PHASE I GRADING & DRAINAGE PLAN
EVER READY OIL
EDITH & CANDELARIA

JOB NO. 920393
DATE 09-1993
SHEET 1 OF 2

PHASE II: GRADING & DRAINAGE PLAN
EVER READY OIL
EDITH & CANDELARIA

DRAINAGE PLAN CALCULATIONS & NOTES
EVER READY OIL
EDITH & CANDELARIA

PHASE II: GRADING & DRAINAGE PLAN	
EVER READY OIL	
EDITH & CANDELARIA	
DESIGNED BY	J.G.M.
DRAWN BY	ACAD.
APPROVED BY	J.G.M.
DATE	3/94 JM
REVISE PER	AS-BUILT

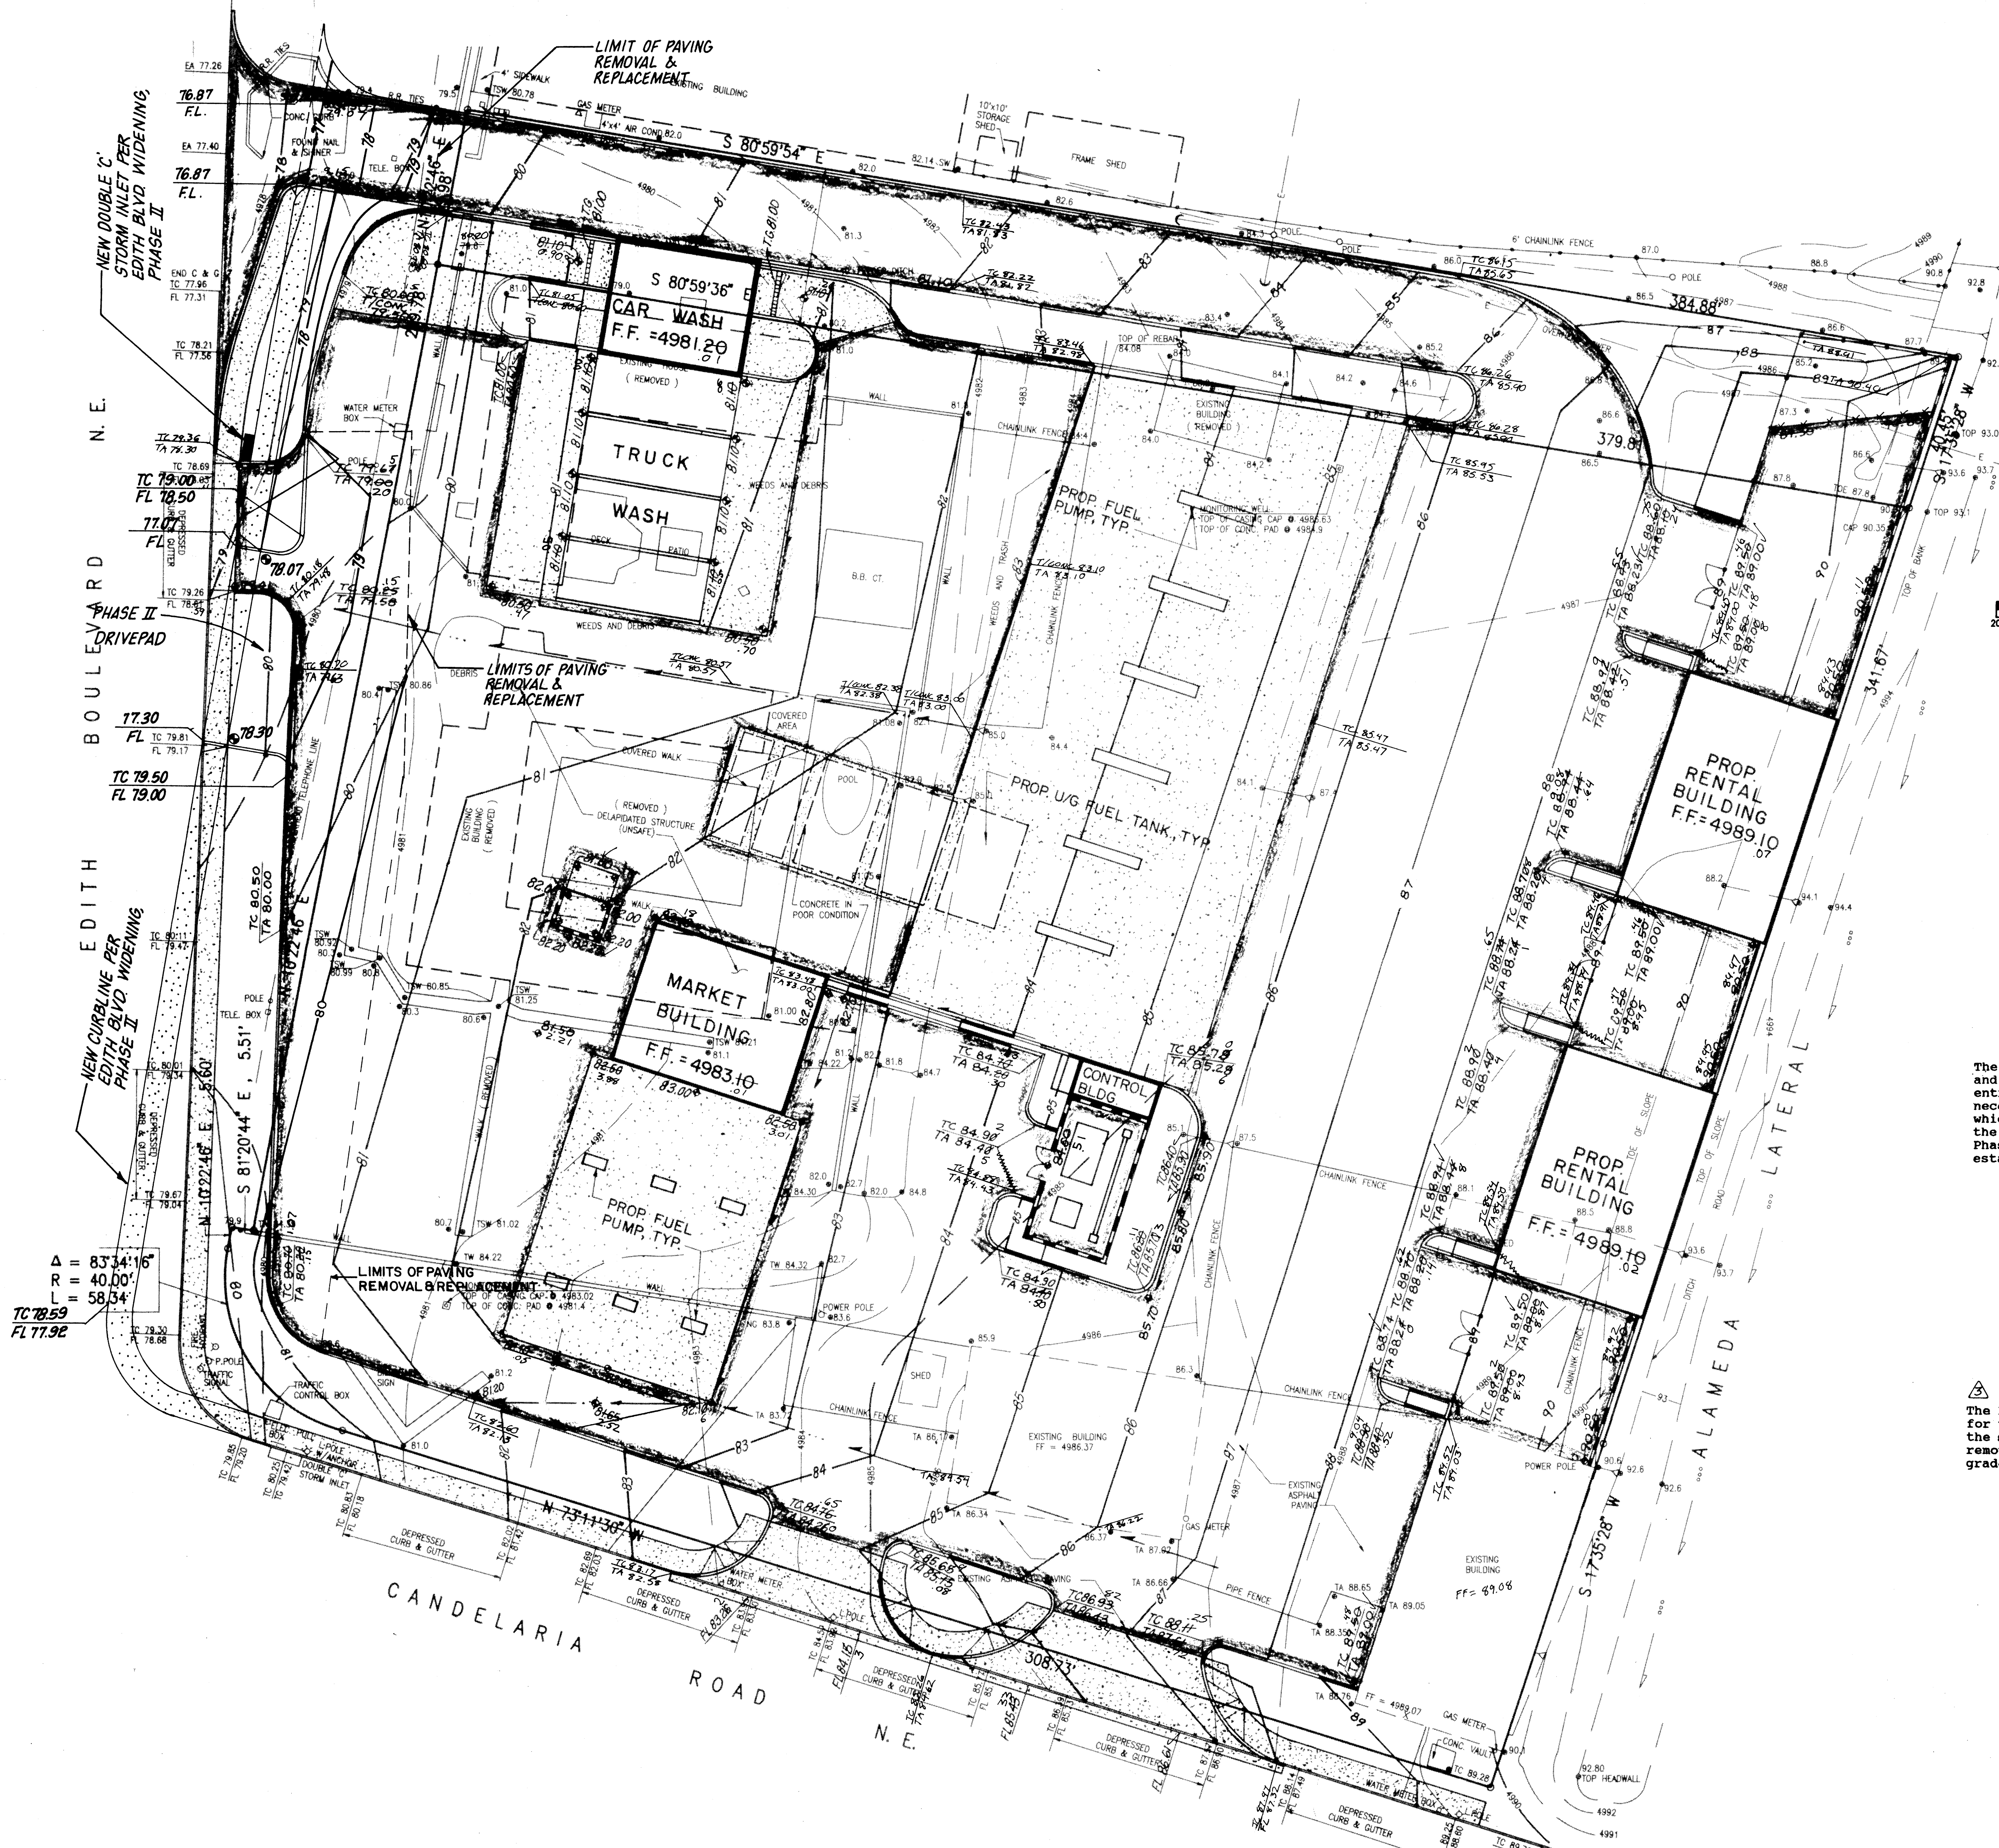
PHASE II REVISIONS

The Phase II Grading and Drainage Plan has been revised to account for the as-built curb and paving elevations along the west edge of the site. These changes are minor, however, the limits of pavement removal and replacement have been expanded to address the as-built grade of this portion of the site.
